Save Manly Oval Alliance

Submission in response to Proposed Manly Oval Underground Car Park

**Sydney Road, Manly
DA 116/2016 by former Manly Council**

17 June 2016

Figure 1 - Long section on Sydney Rd and westbound Exit Ramp

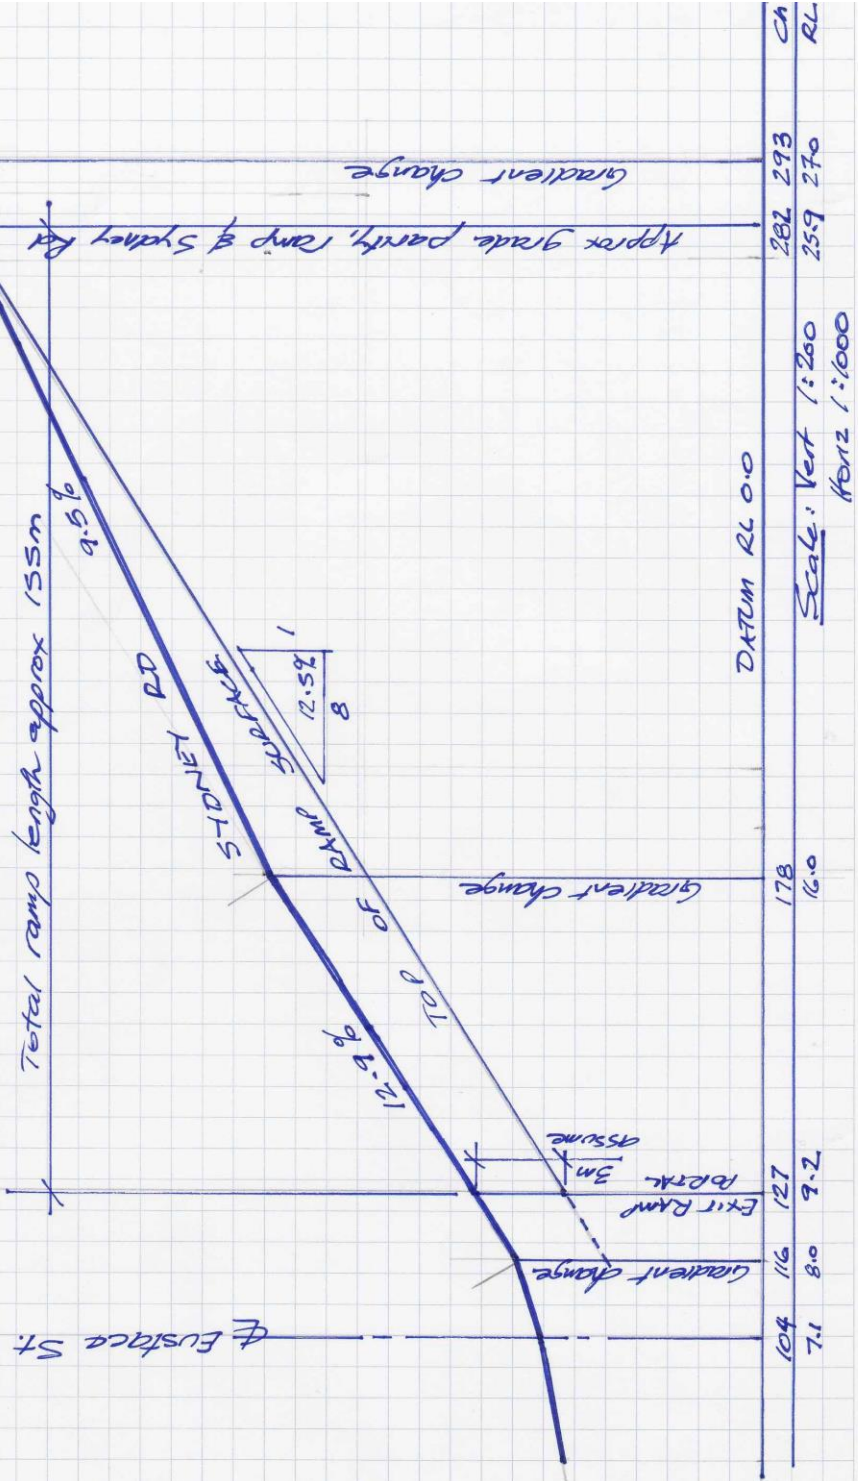
The calculations and details of the ramp and road interfaces are shown in Figure 1.

Figure 1 assumes the open ramp floor level is about 3.0 metres below ground level when it emerges from tunnel portal (2.2m minimum vehicle height + 300mm additional height to avoid vehicle-bottoming through the grade transition + 300mm structural roof depth + 200 mm road pavement thickness = 3.0 m). This depth will increase to about 3.28 m by the top of the 12.9% grade section, and will not reach Sydney Road grade until a further 105 metres have passed. The total ramp distance will be about 155 metres, extending past No 73 Sydney Road.

Figure 2: Contour map of Sydney Rd from Belgrave Street westwards

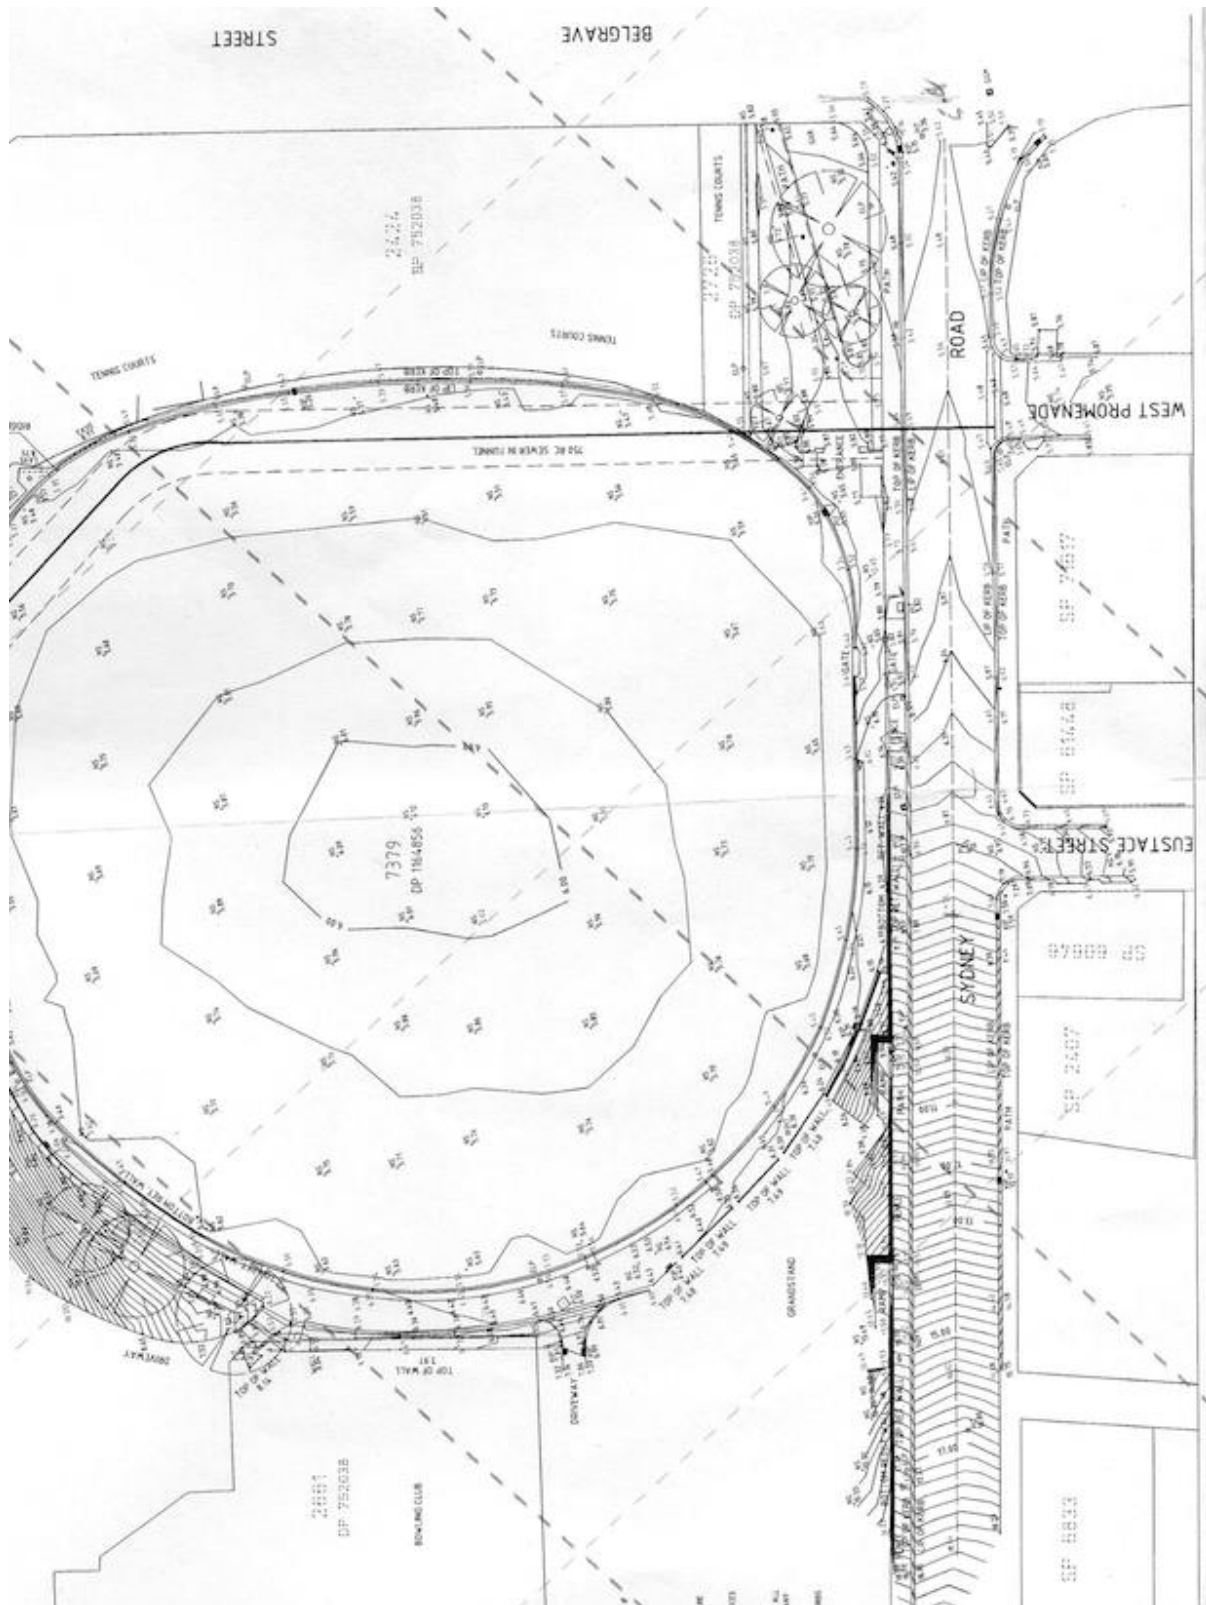
One of the traffic options presented in the plans submitted by Manly Council includes a new roundabout to be constructed at the intersection of Eustace St and Sydney Rd¹¹. This roundabout will replace an existing Tee-intersection at that point. Eustace St joins Sydney Rd immediately at the bottom of a steep (12.9% grade) hill¹², and indeed the intersection is within the tangent points of the sag curve between the steep 12.9% section and the substantially flat section of Sydney Rd beyond Eustace St. The contour map at

Figure 2 shows this intersection and the comparison of slopes as shown by the contour lines.

The purpose of the intersection is to provide easy access for traffic to enter the car park through the only entrance to the car park, either by turning right out of Eustace St, or by encouraging westbound traffic in Sydney Rd to make, effectively, a U-turn to enter the eastbound entrance ramp. These proposed traffic movements would dramatically increase the traffic turns at the Eustace Street/Sydney Road intersection and greatly increase the risk of serious accidents at that intersection.
